**Lime Down Solar Park  
(Planning Inspectorate Reference: EN010168)**

**Wiltshire Council Response to  
Statutory Consultation**

**March 2025**

Figure 2

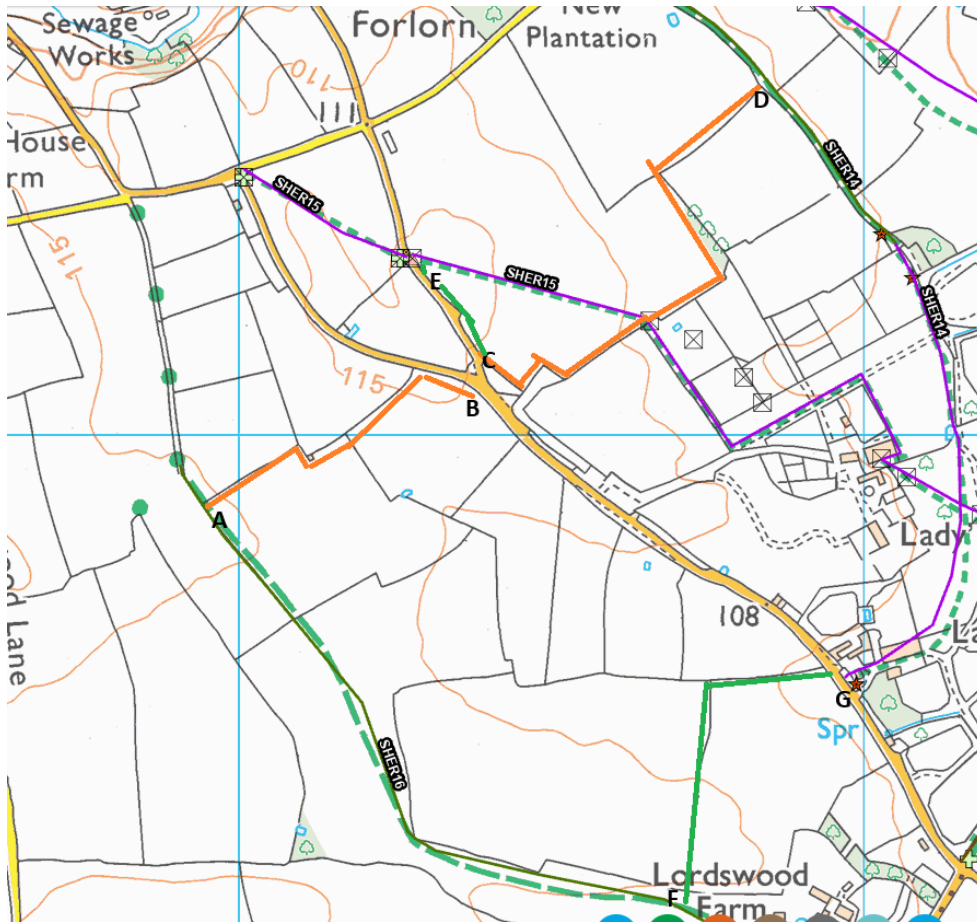
- 14.9 The Lime Down A component of the scheme provides an opportunity to link Bridleway SHER14 with Bridleway SHER16 if a Public Bridleway was created by following a route of A-B-C-D. It might also be possible to divert a section of SHER15 onto the field edge to improve the management of the land. A new Public Footpath from point G-F could link SHER14 to SHER16, which is considered would create a nice circular route option. These are shown on Figure 2 below:

14.10 The council considers that the following improvements would be necessary:

Figure 4

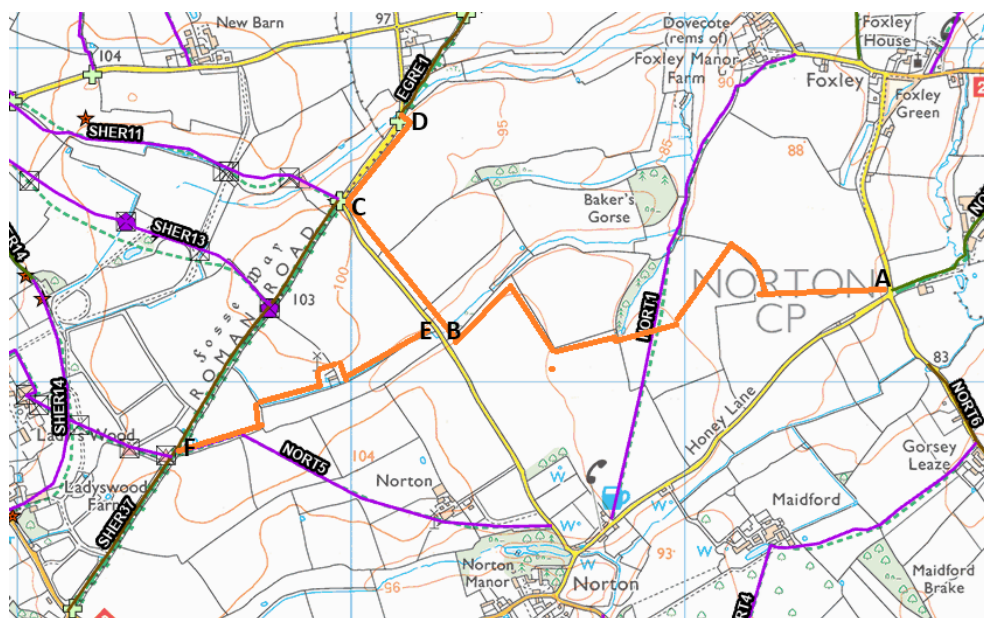
14.13 The proposals regarding Lime Down B, offer a very welcomed opportunity to link Public Bridleway NORT11 to Byways Open to All Traffic EGRE1 and SHER37, which could then in turn link the user to Bridleway SHER16 via a link through the Lime Down C site. This route is shown in Figure 4 below as A-B-C-D and A-B-E-F.

14.14 The council considers that the following improvements would be necessary:

Figure 6

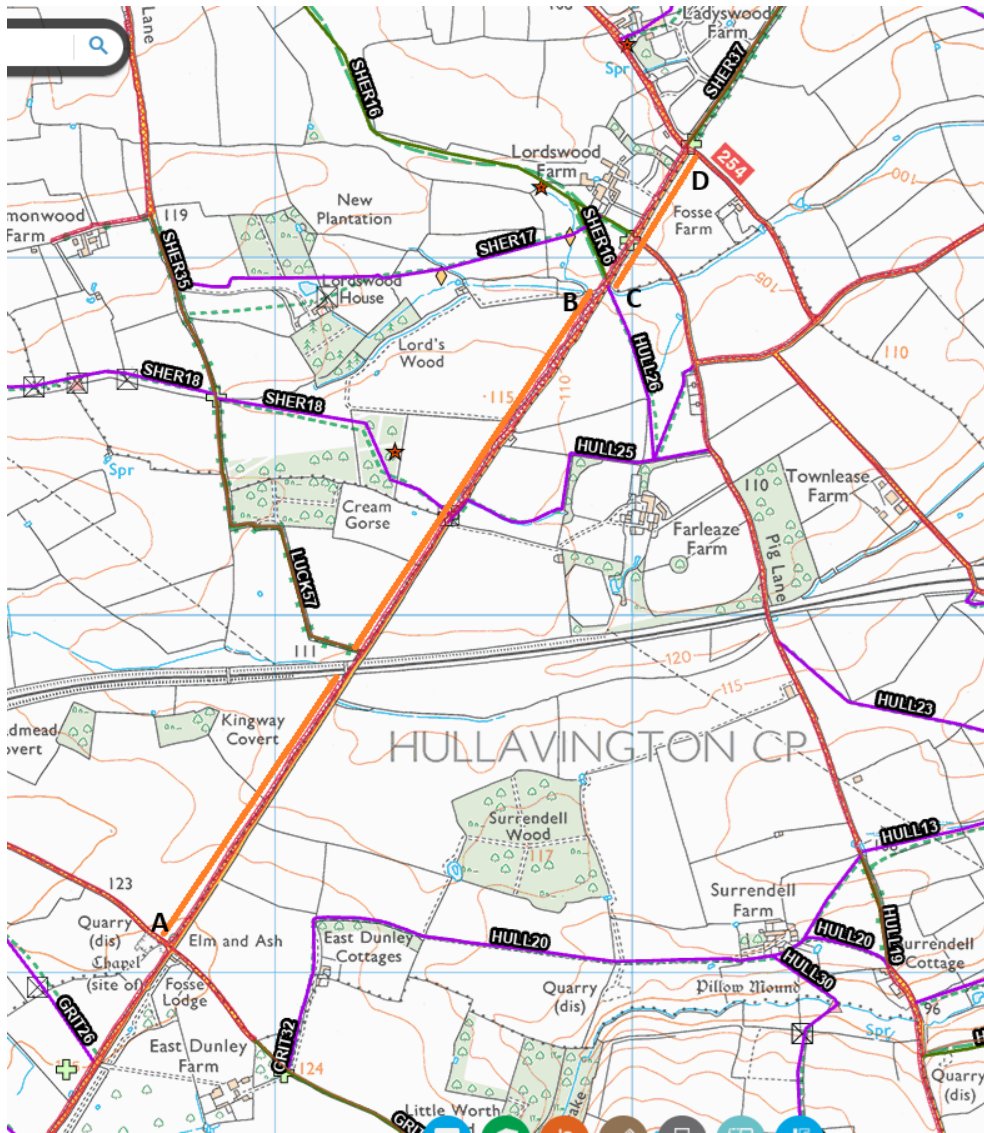
14.17 The proposals regarding Lime Down C, create an opportunity to create a new Public Bridleway on the west side of the Fosse Way. This could link the following public rights of way: GRIT22, LUCK57, SHER18, HULL25, SHER16 and SHER37. This is shown on Figure 6 below:

Figure 7

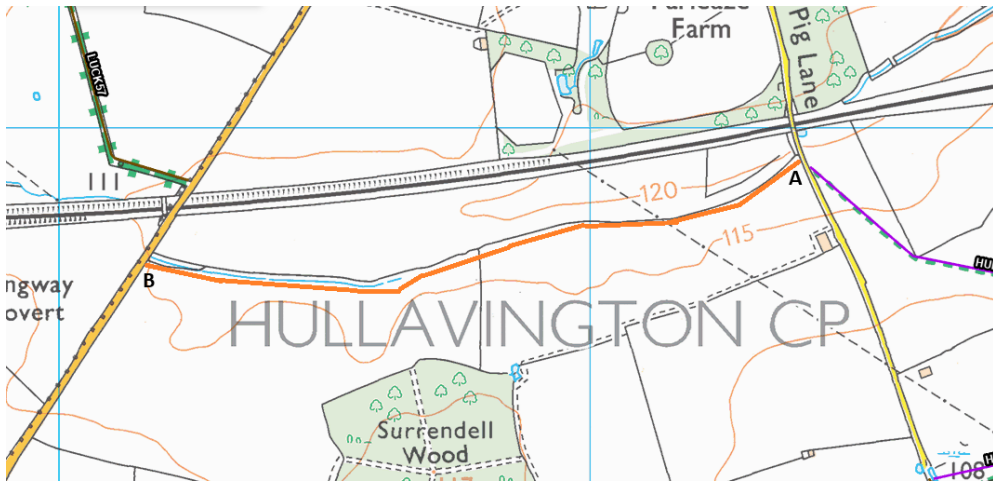
14.18 The proposals regarding Lime Down C also create an opportunity to provide a new Public Footpath. This route is shown on Figure 7 below as A-B and would link HULL23 with LUCK57. The council suggests that this is located on the south of the hedge and panels due to the user having improved views and also due to the access point onto the road.

Figure 9

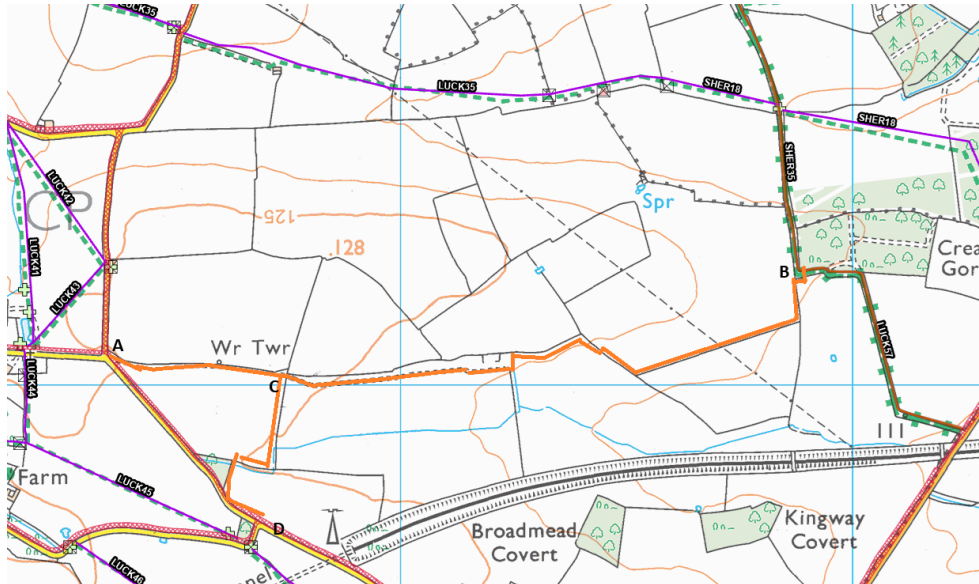
14.22 A new Public Bridleway (shown in Figure 9 below) should be created linking A-C-B, which will link Alderton and Luckington to LUCK57. A new Public Footpath should also be created between points D-C as this would create a circular route connecting with LUCK45.

Figure 10

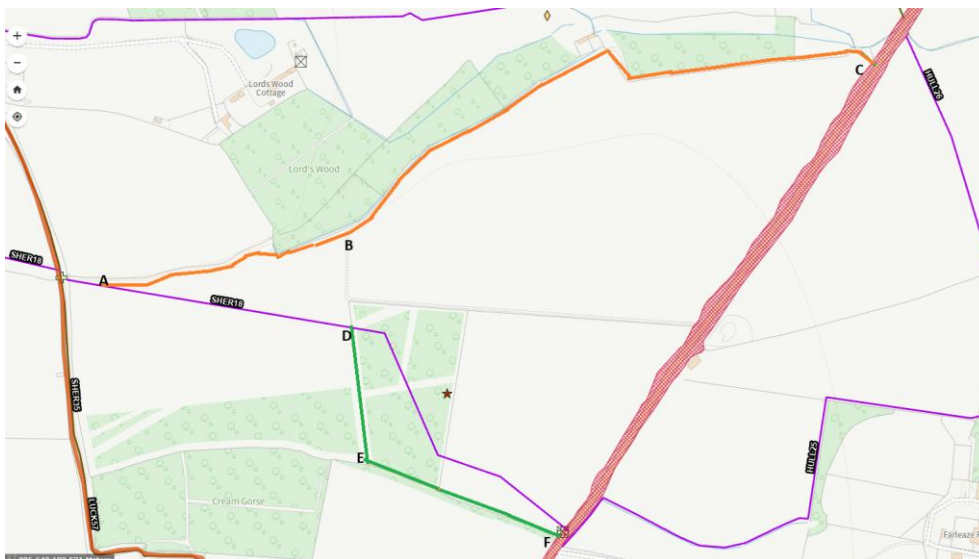
14.23 The council's PROW Officer is unsure whether SHER18 is available on the definitive line through Cream Gorse, therefore this proposal would give the option of improving the connectivity of the network and also improve land management. It may be possible to divert SHER18 onto the route A-B-D-E-F shown in Figure 10 below, which would also improve connectivity with HULL25. A Public Footpath dedicated along the route of A-B-C would also add to the connectivity of the public rights of way network.

Figure 12

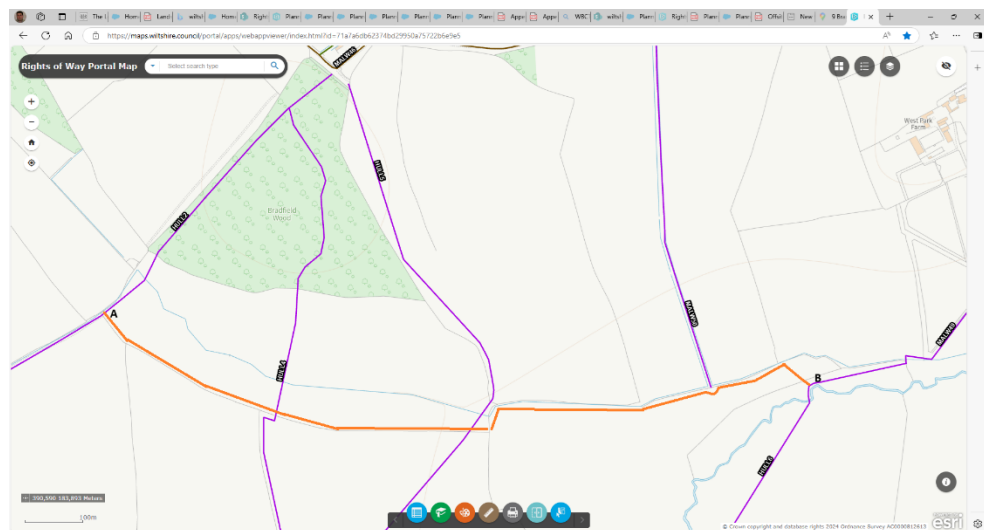
14.30 A new Public Footpath to link HULL2, HULL4, HULL5, HULL6 and MALW50 should be created between points A-B (as shown as the orange line in Figure 12 below). It is considered that this possible route would avoid the solar panels.

Figure 13

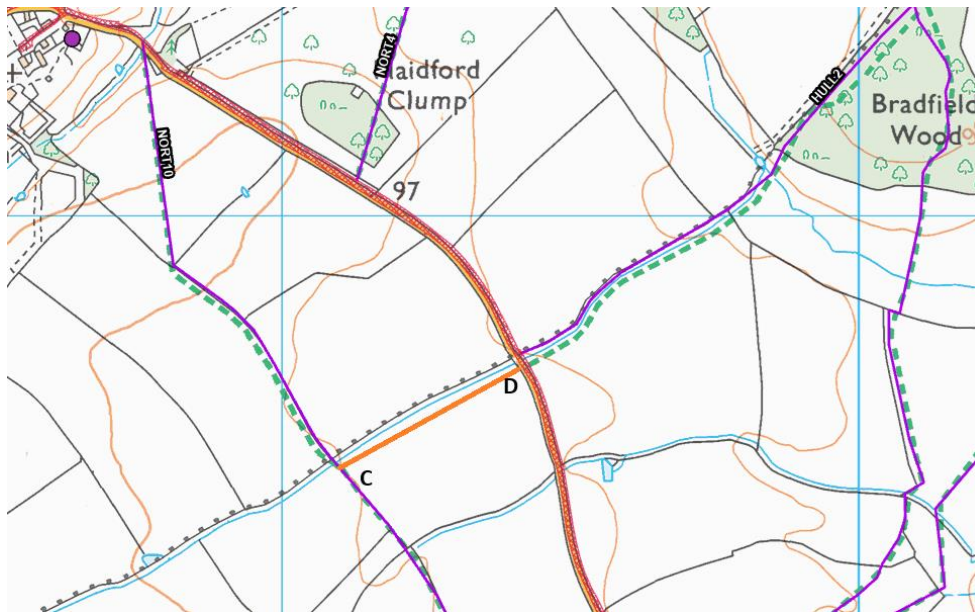
14.31 The council also considers that a new Public Footpath should be created between HULL1 and HULL2 as shown on Figure 13 below. HULL2 is currently isolated from the PROW network at its western end. The nearest public footpath is over 400m to the north along Norton Road and to the south, it is over 700m before a connection with

another PROW. If the applicant was to dedicate a new Public Footpath between HULL1 meeting Norton Road opposite HULL2, this would increase the walking options in the area, opening more circular route options. Furthermore, it is noted that there is a housing development of up to 71 units in construction at the southern end of HULL1, therefore it would be of benefit to the new residents.

Figure 15

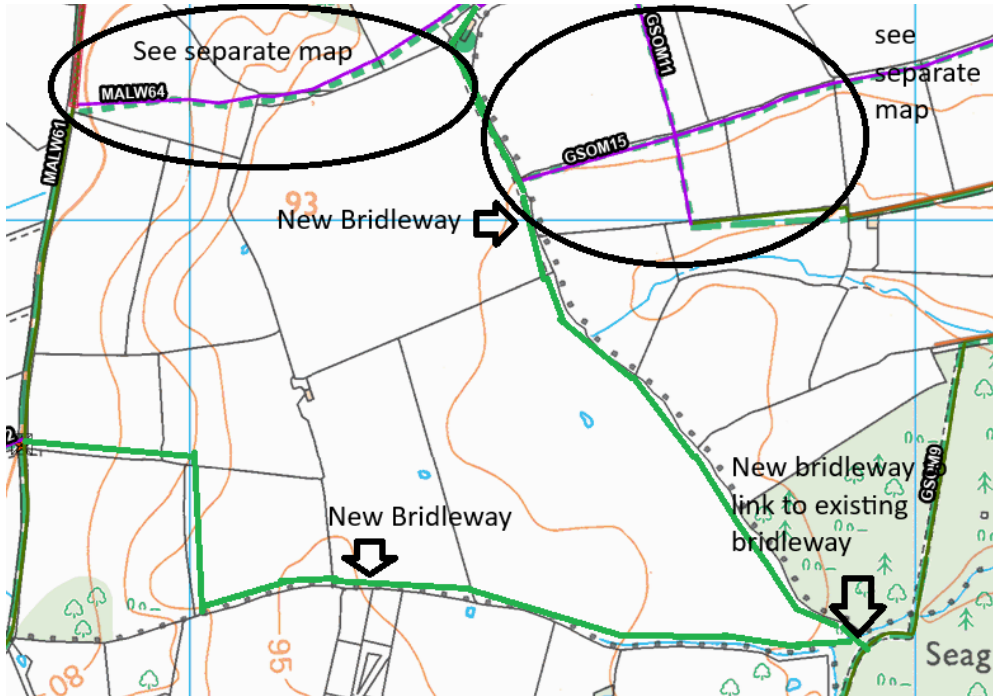
14.36 Furthermore, a Bridleway could be created up the east side of the Lime Down E site to link with MALW64 near Cleeve House. Please see Figure 15 below:

Figure 16

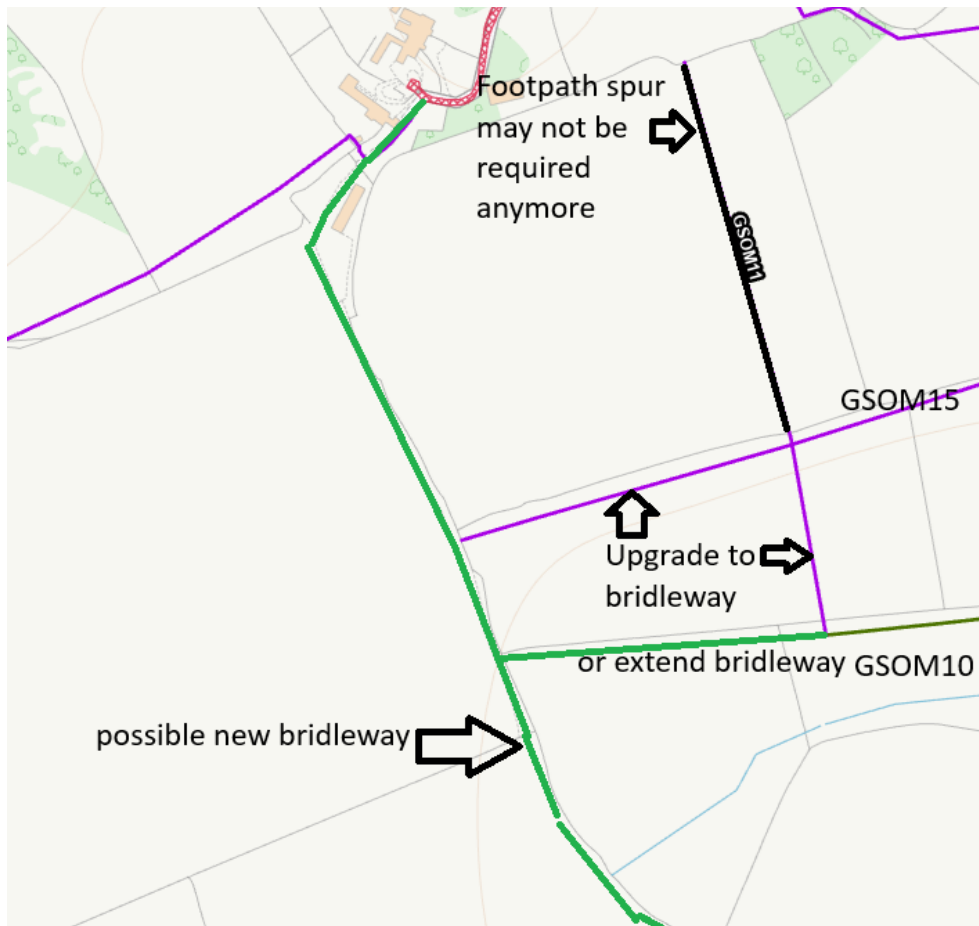
14.37 Additionally, part of GSOM11 and GSOM15 could be upgraded to a Bridleway or extend GSOM10 to meet Lime Down E as a Bridleway, which may result in the possibility to extinguish the north part of GSOM11 in exchange for network improvements. This is illustrated on Figure 16 below. It is acknowledged that Grove Farm would need to agree.

Figure 17

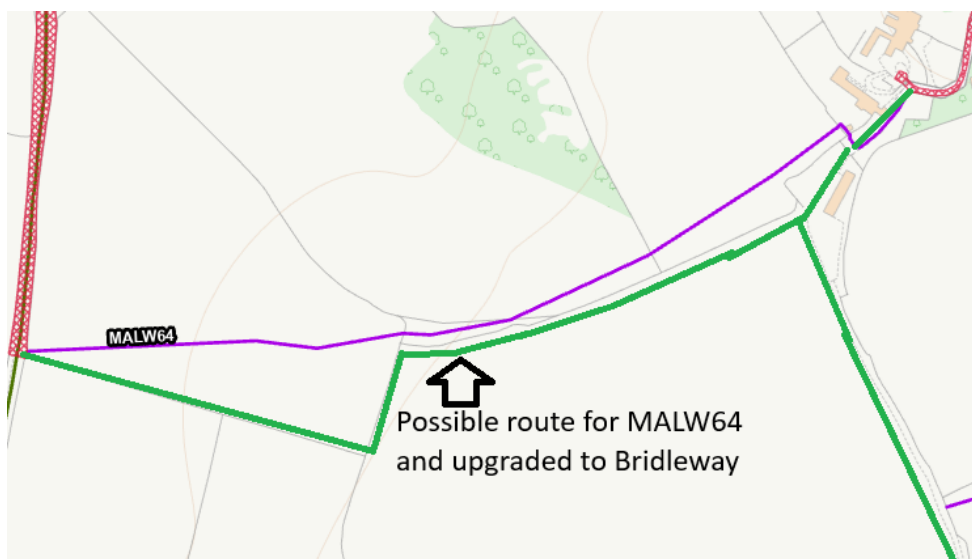
14.38 It may also be possible to divert MALW64 from its current alignment to a route following the field edge around the solar farm. This path could also be upgraded to a Bridleway as well to improve the bridleway network connectivity. It is noted that there are several possible route options, which could be considered. Figure 17 below illustrates one of them.

Figure 18

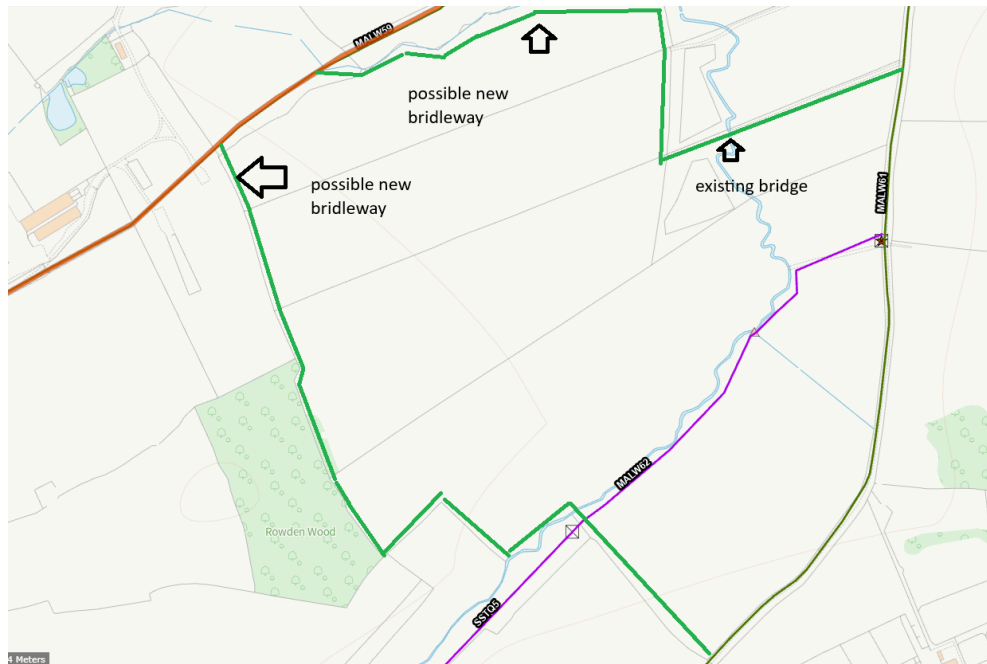
14.39 The proposed development on Lime Down E also provides the opportunity to link MALW59 to MALW61 (Figure 18). The western end of MALW59 terminates at the A429 (Figure 19). There is very limited highway verge at this location with over 650m of the A429 needing to be traversed to the south before being able to join a quieter and slower speed section of highway. Over 650m of the A429 also needs to be traversed to the north before the turning to Hullavington. Please see Figures below.
